## **Planning Commission Tentative Agenda**

**Thursday, September 18, 2025**

**6. VAR-2025-0040: Planning Commission Variance (E. MARTIN LUTHER KING JR BLVD & S. COLLEGE AVE/CINQUEFOIL LLC, 523):**

Figure 12.11 - Neighborhood Link Street

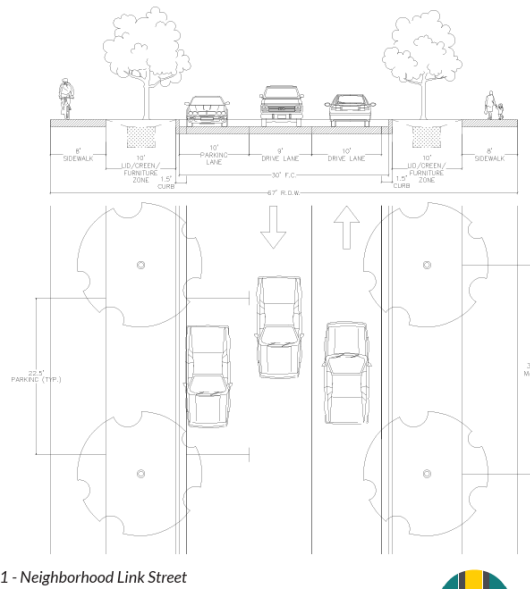
*Request:* The request is for a lesser dedication of right-of-way than is typically required by the master street plan for a neighborhood link street. Where 67 feet of right-of-way would typically be required (or 33.5 feet from street centerline), the applicant is requesting to dedicate only 55 feet, or 27.5 feet from street centerline.

**DISCUSSION:**  
Staff recommends denial of the applicant's request to dedicate less right-of-way than is typically required by the Master Street Plan. The typical master street plan requirements for a

Neighborhood Link Street call for two lanes of traffic, and a third lane for on-street parking. That said, there are certain considerations that are called out in the master street plan requirements to allow for flexibility in the design where warranted. This includes flexibility for the allowance of a dedicated turn-lane. City Engineering staff have identified that left turn lane improvements will be needed at this location in the future to maintain safety and capacity at this location. High traffic counts and over 20 crashes within a 5-year time-frame from 2017-2021 at this location have indicated to Public Works that intersection improvements are needed, especially as development continues to occur in the area. It is standard under the requirements in §166.04 that an applicant dedicate right-of-way in alignment with the master street plan requirements with an associated development. While staff can make necessary administrative reductions, staff finds that it is not warranted in this instance to reduce the master street plan requirement beyond the typical requirement for 33.5 feet.

Engineering Staff does not support the variance request to reduce the required right-of-way dedication along MLK Blvd. from 67' to 55'. This dedication is essential for plans to add a left-turn lane at the intersection of MLK Blvd. and S. College Ave.

Staff recognizes the challenges of adding turn lanes due to the offset intersection and nearby structures. However, acquiring the right-of-way now, before the land is developed, is critical. This is considered a best practice for transportation planning. If this dedication is not provided at this time, the northwest corner of the intersection will be built out, creating significant obstacles to the future construction of the turn lanes. Unfortunately, the other corners of the intersection are already built out to some degree and will require future right-of-way dedication as part of a future redevelopment project, or an acquisition of the property by the city.

I am requesting a variance from the Master Street Plan ROW dedication requirement for MLK Blvd. The Master Street Plan seeks to widen the street and install a turning lane at this corner. We believe this is inadvisable for two reasons.

Therefore we request that the ROW remain at the minimum of 55' for a Neighborhood Link per the Master Street Plan adopted as part of City Plan 2040.

SITE CONCEPT DRAWING, JOHNSON STORE  
18 November, 2024 Scale: 1" = 20'

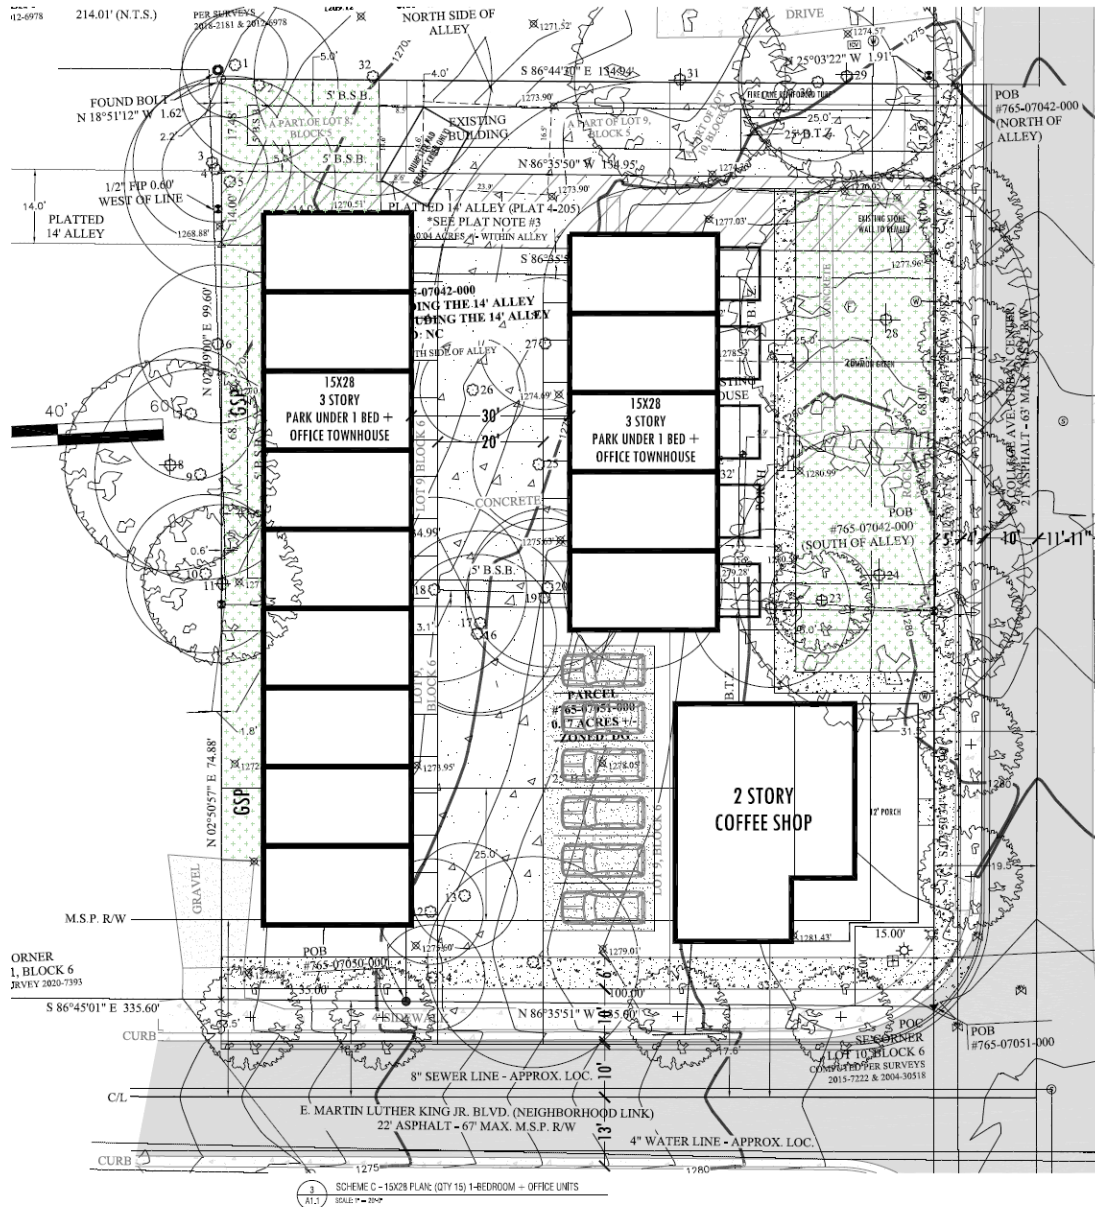
Engineering staff does not support the variance request to the curb cut separation at the proposed site. The applicant's site plan provides 83' of separation, which fails to meet the 100' requirement specified in the code (§166.08(F)) for Neighborhood Links. It is staff's opinion that granting this variance could reduce public safety at a relatively high-volume intersection. Staff's review of this matter included consideration of the following:

- Traffic Volume: The intersection of MLK Blvd. and S. College Ave. is a relatively high-volume intersection (13,000 and 4,200 vehicles per day, respectively) and these volumes will likely increase in the future as more development occurs in the southeast part of town.
- Turn Lanes: To accommodate traffic growth, the city has long-term plans to install left turn lanes at this intersection, which would be impacted by a non-compliant curb cut.
- Intersection Offset: The 12' north/south horizontal shift of MLK Blvd. as it crosses S. College Ave. requires drivers to adjust their lane position. Maximizing the distance between the driveway and the intersection would provide additional reaction time for drivers, enhancing safety.

It is Staff's opinion that these are two different scenarios with different considerations. The fact that staff would approve a reduced separation in Scenario 2, where it is not feasible to meet the code, does not inform the decision for Scenario 1, where compliance is feasible.

Finally, if the Planning Commission decides to grant the variance for the full development, staff recommends requiring the driveway to be right-in/right-out only. The applicant has previously offered this as an option, and staff agrees it would help mitigate the safety risks associated with a non-compliant separation distance.
